The above-identified patent application has been amended and Applicants respectfully request the Examiner to reconsider and again examine the claims as amended.

Appl. No. 09/769,166 Reply to Office Action of February 17, 2004

FIG.~4

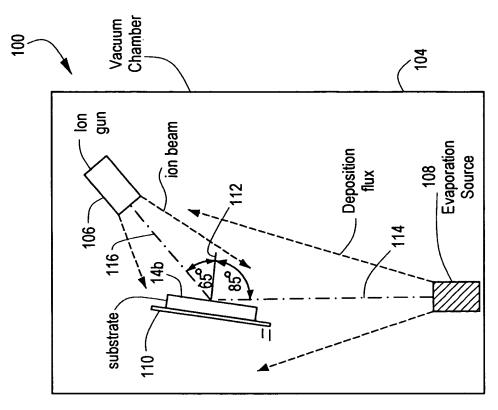
In FIG. 4, delete "20a" and replace with --22a--, --22b--, and --22c-- as shown and move

the surface lines associated with 22a and 22b to match the hand drawn drawing as originally filed;

More specifically, FIG. 4 as originally submitted does not describe nor suggest a <u>surface</u> substantially flat and substantially parallel to the surface of the first substrate.
